Grand Re-Opening Historic Clarksburg Store

SUBJECT: Historic Area Work Permit # 409314 for porch reconstruction and rehabilitation of store

HISTORIC PRESERVATION COMMISSION STAFF REPORT

Address:	23341 Frederick Road, Clarksburg	Meeting Date:	02/08/06	
Applicant:	Nicole Lewis	Report Date:	02/01/06	
Resource:	Outstanding Resource Clarksburg Historic District	Public Notice:	01/25/06	
Review:	HAWP	Tax Credit:	N/A	
Case Numbe	er: 13/10-06A	Staff:	Michele Oaks	
PROPOSAL: Porch Re-construction, Rehabilitation of Store

(1)	FRONT	ELEVATION		
A1-3			SCALE:	1/4" =1'-0"

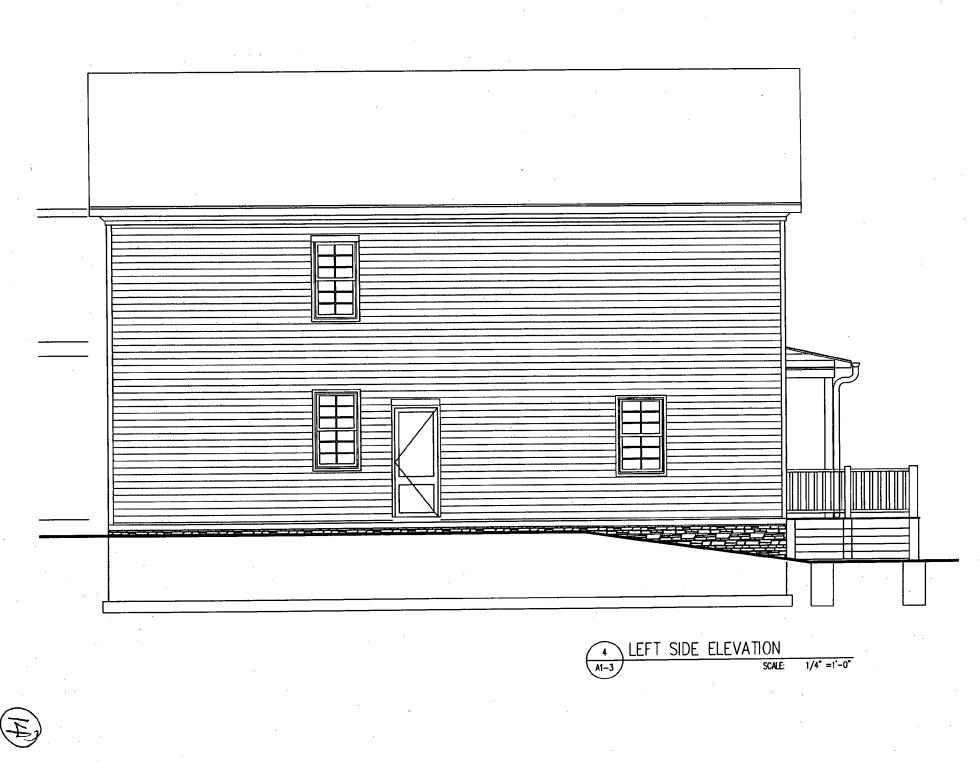
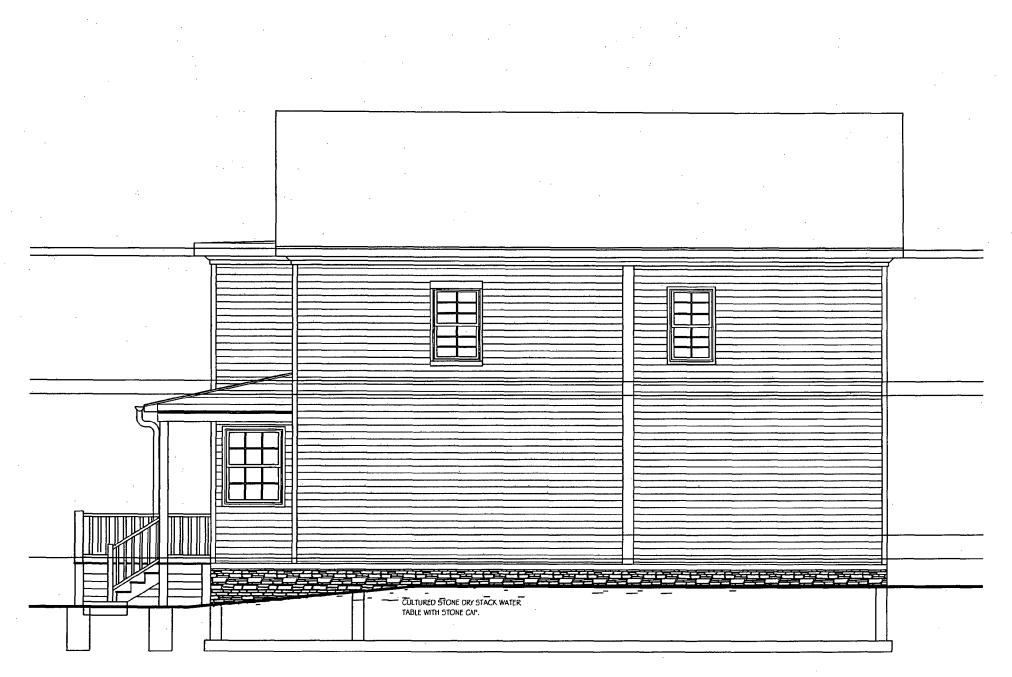
• The front porch roof in front of the post office will be re-designed so that the roof covers the entire surface area of the decking.
